City of Woodburn
Community Development Dept.

Memorandum

Date: May 3, 2023
To: Dago Garcia, P.E., City Engineer
Cc: Roy Reyes, Project Engineer
John Raugust, PE, AKS Engineering & Forestry
From: Colin Cortes, AICP, CNU-A, Senior Planner *cc*
Subject: **Planning Division review comments on 4th / 3rd revised submittal May 1 of civil engineering plans for Macadam at Tukwila PUD (f.k.a. Marion Pointe)**

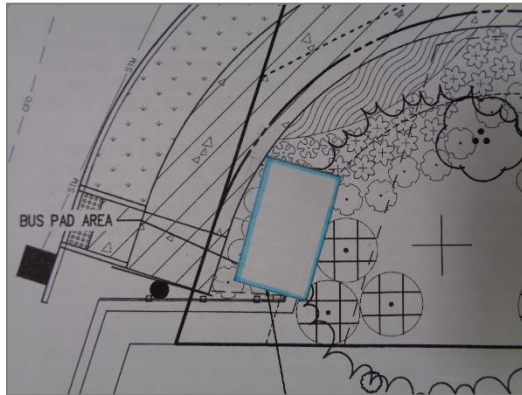
Sheet L106 is revised to add groundcover; however, it appears the item was misunderstood because the groundcover is added along the south side of the golf cart path. The groundcover is supposed to be in the "buffer area" that is between the golf cart path north side and sidewalk south side.

Second, a call-out note indicates "kinnikinnick", but doesn't also specify min plant quantity at 1 plant per 3 ft of buffer length, which appears to equal $70 \text{ ft} / 3 = 24$ plants, so 24 plants.

→ In short, in the area *between* golf cart path and sidewalk, add groundcover (e.g. kinnikinnick) and revise the call-out note to specify minimum 24 plants with average spacing of 3 ft.

Preferred

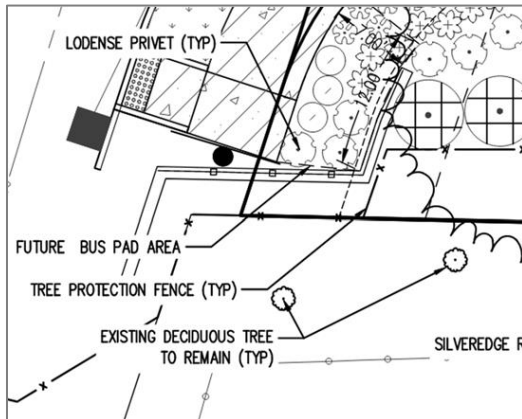
The Sheet L105 delineated and noted area isn't minimum 12 ft wide parallel to the road and 7 ft deep between sidewalk and retaining wall. ...

✘ ... The photo below of marked Sheet L105 illustrates the scaled blue-outlined rectangle aligned with sidewalk without encroaching on the sidewalk curve to the northeast. It illustrates that the NE segment of the proposed retaining wall can't fit a pad 7 ft deep from sidewalk and 12 ft wide along sidewalk ...

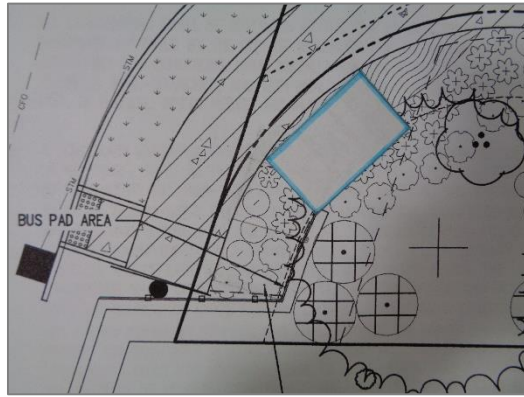
Sheet L105 is revised per the excerpt below; however the delineated and noted pad area is a curving polygon instead of a rectangle.

➔ In short, to have the retaining wall the way the developer wants, revise to move the delineated pad area northeast beyond both wall and sidewalk similar to the photo below:
